Sewage Disposal System Upgrade
In The Town Of
Chilmark

Site: Existing Garage w/ Proposed Office Above Map 25, Parcel 6.1 29 Welles Way	Owner: Ariel & Zachary Heinzerling Ashe 611 Broadway #722 New York, NY 10012
Scale: As Shown	Date: June 8, 2022
Job No.: 102558	Drawn By: E. Chen
Revised No.: 102558R01	Designed By: E. Chen
Sheet: 1	Checked By: E. Seurat

Plan of Land
SCALE: 1:500
MAP NO. 25
PARCEL NO. 6.1
AREA: 49,200 SF.

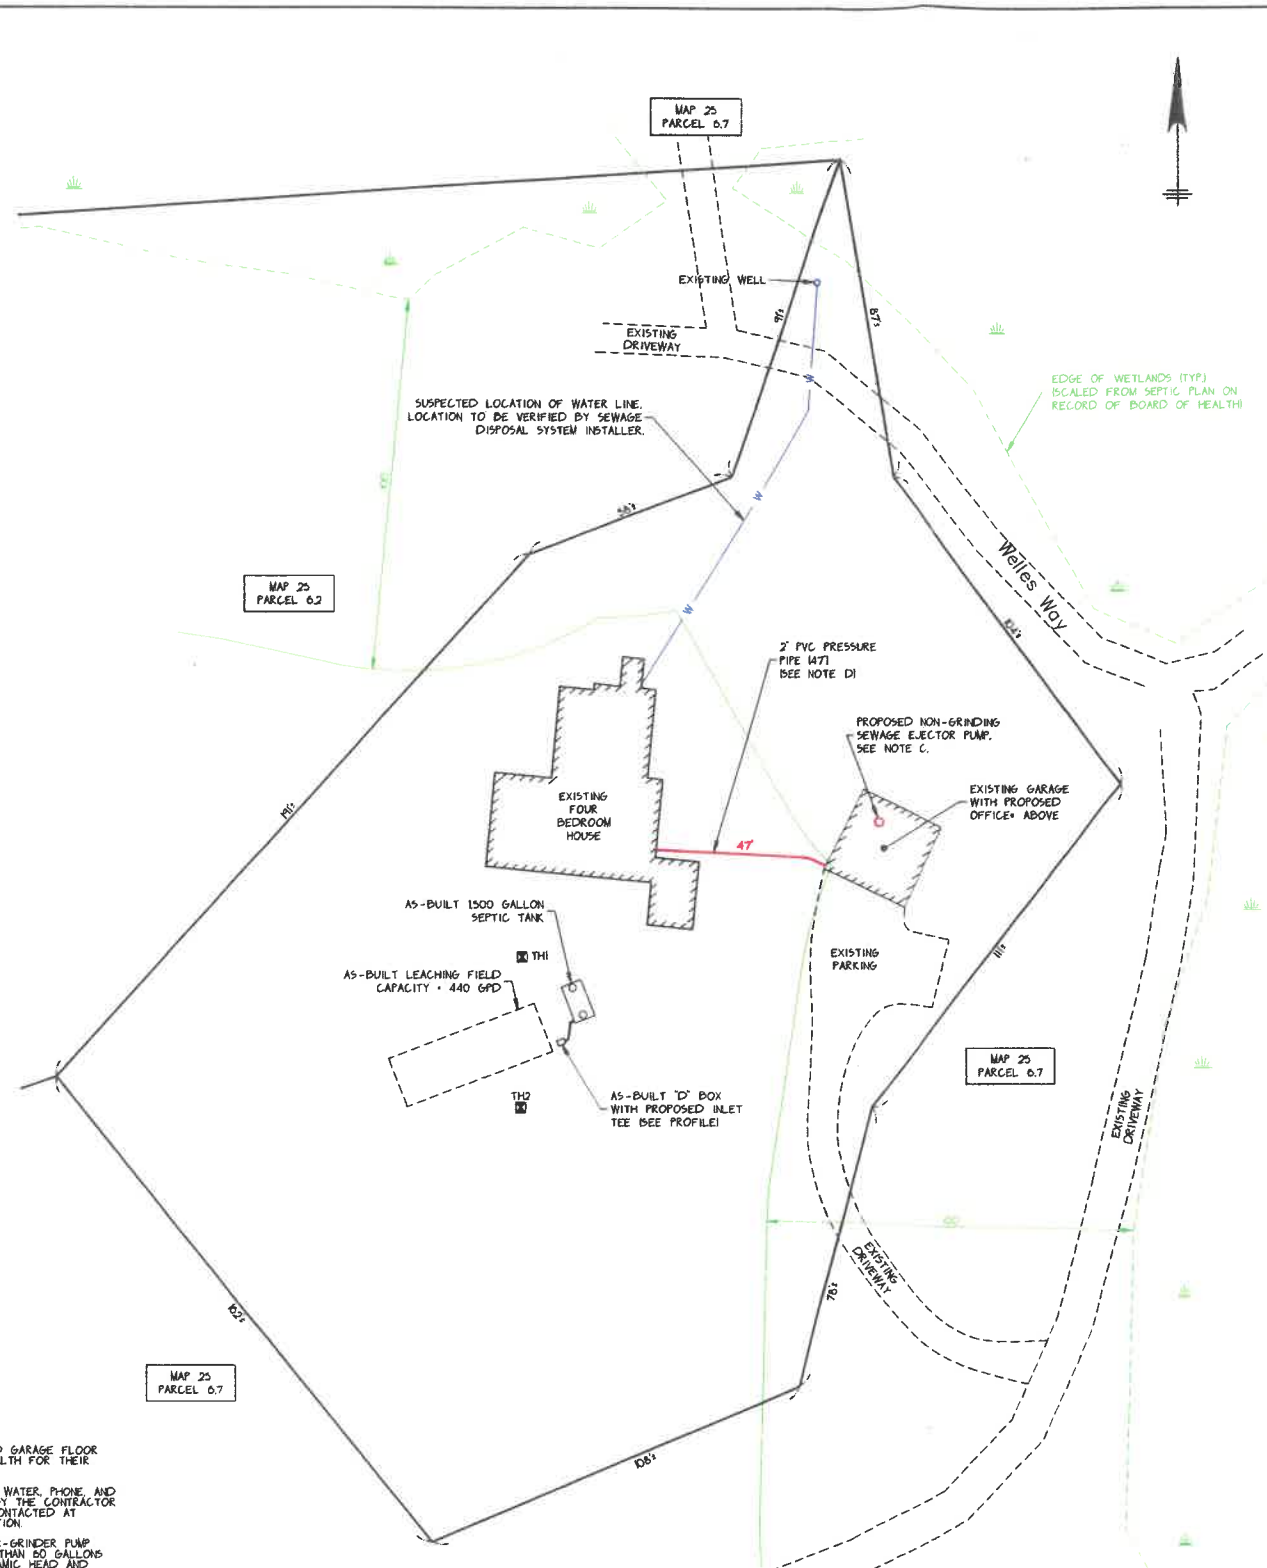
want to put sewage ejector in garage & tie in to plumbing in the house
